UNITED STATES
 NUCLEAR REGULATORY COMMISSION
 WASHINGTON, D. C. 20553

LICENSEE: Texas Utilities Electric Company (TU Electric)
 FACILITY: Comanche Peak Steam Electric Station, Units 1 and 2 (CPSES)
 SUBJECT: SUMMARY OF MEETING ON CPSES THERMO-LAG TESTING PROGRAM

CPSES THERMO-LAG TESTING PROGRAM

**THERMAL ANALYSIS MODEL FOR
CONDUIT TEST ASSEMBLY**

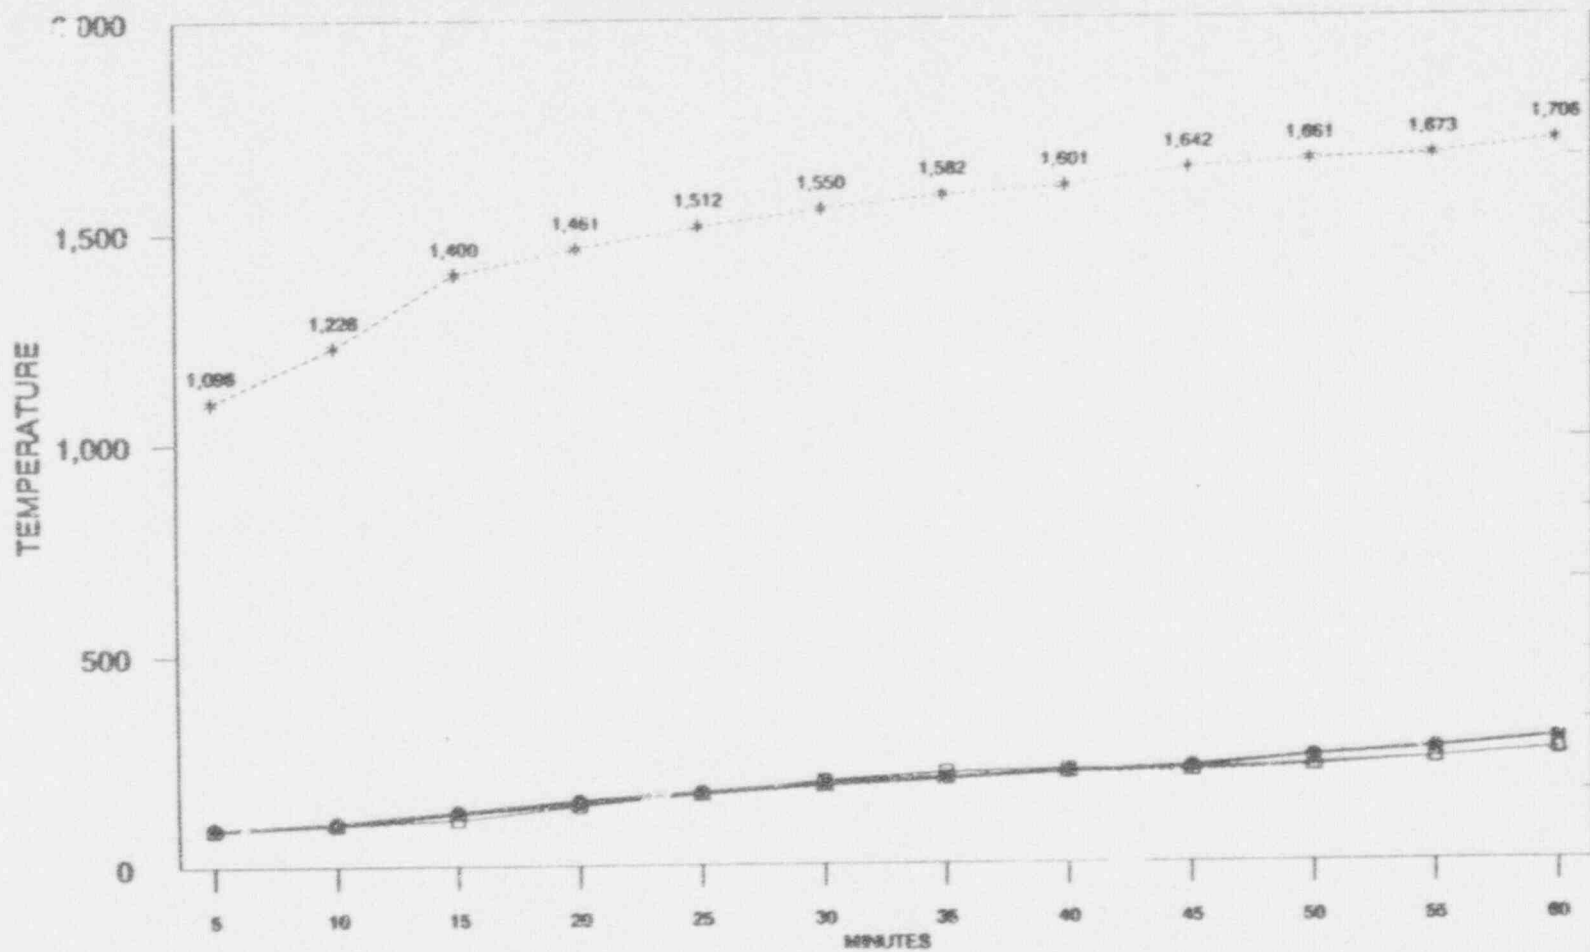
- * SUPPORTS WERE NOT CONSIDERED WITHIN THE BOUNDS OF THE RACEWAY FIRE BARRIER QUALIFICATION TESTING. SEPARATE ANALYSES DEMONSTRATE THAT SUPPORTS WILL NOT FAIL DUE TO SUPPRESSION SYSTEMS AND LOW COMBUSTIBLE LOADING (THIS IS FURTHER DISCUSSED IN THE NEXT ISSUE).
- * THERMAL ANALYSIS HAS BEEN PERFORMED FOR THE CONDUIT ASSEMBLY TESTED WHICH DEMONSTRATES THAT THE SUPPORTS HAVE NEGLIGIBLE EFFECT IN CONDUCTING HEAT AWAY FROM THE TEST ENVELOPE.
- * SUBSEQUENT TESTS WILL MINIMIZE THE NUMBER OF SUPPORTS AND CLOSELY MODEL PLANT SUPPORT SPACING. SUPPORTS WILL BE PROTECTED WITH A SINGLE LAYER OF THERMO-LAG. THERMOCOUPLES WILL BE INSTALLED ON THE CONDUIT ASSEMBLY SUPPORT TO MEASURE TEMPERATURE DIFFERENTIAL FROM THE TEST ENVELOPE.

Determine heat loss (change in temperature) of the 24"x18"x8" junction box due to thermal conduction into the support steel.

Using these very conservative assumptions there was a 15 degree F maximum reduction in temperature on the junction box steel for the one hour ASTM E-119 exposure due to the transfer of heat through the support.

**C-CURVE FIRE: SPRINKLER ACTUATION:
5 MINUTES
SUPPORT YIELD WITHOUT
SPRINKLERS:
42 MINUTES**

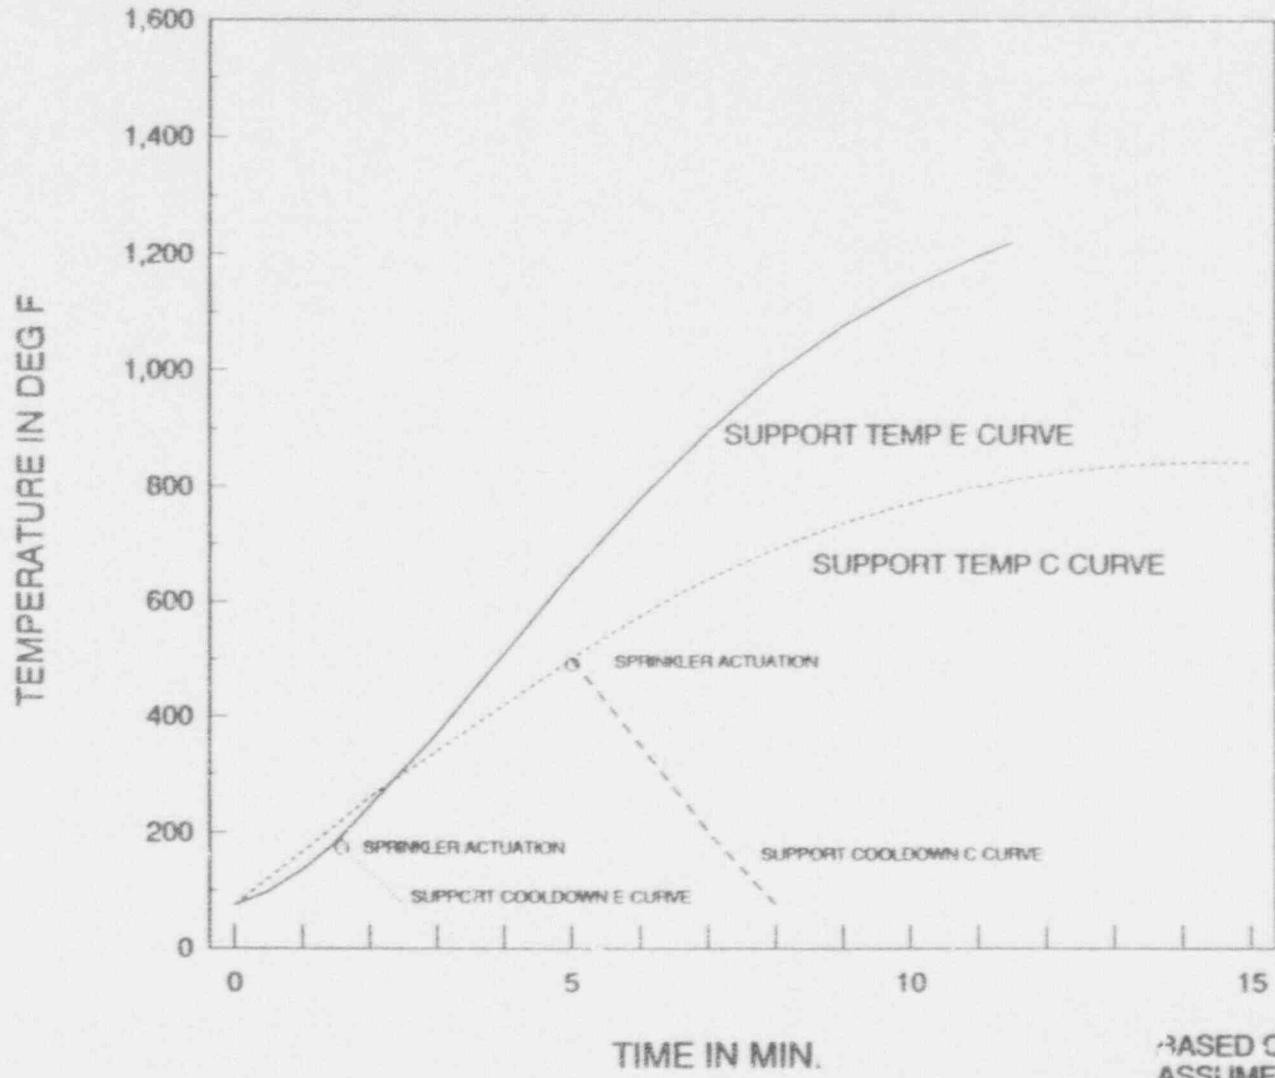
FOR AREAS WITH SPRINKLER PROTECTION, DEMONSTRATE SPRINKLERS WILL ACTUATE AND SUPPRESS THE FIRE BEFORE THE SUPPORTS REACH THEIR YIELD POINT. FOR AREAS WITHOUT SPRINKLER PROTECTION, DEMONSTRATE LOW COMBUSTIBLE LOADING AND ADMINISTRATIVE CONTROLS ENSURE SUPPORT INTEGRITY WILL NOT BE CHALLENGED BY A DESIGN BASIS FIRE.

1. BASED ON THIS VERY CONSERVATIVE APPROACH, SPRINKLERS WILL ACTUATE AND SUPPRESS THE FIRE, WELL BEFORE THE SUPPORTS REACH THEIR YIELD POINT.
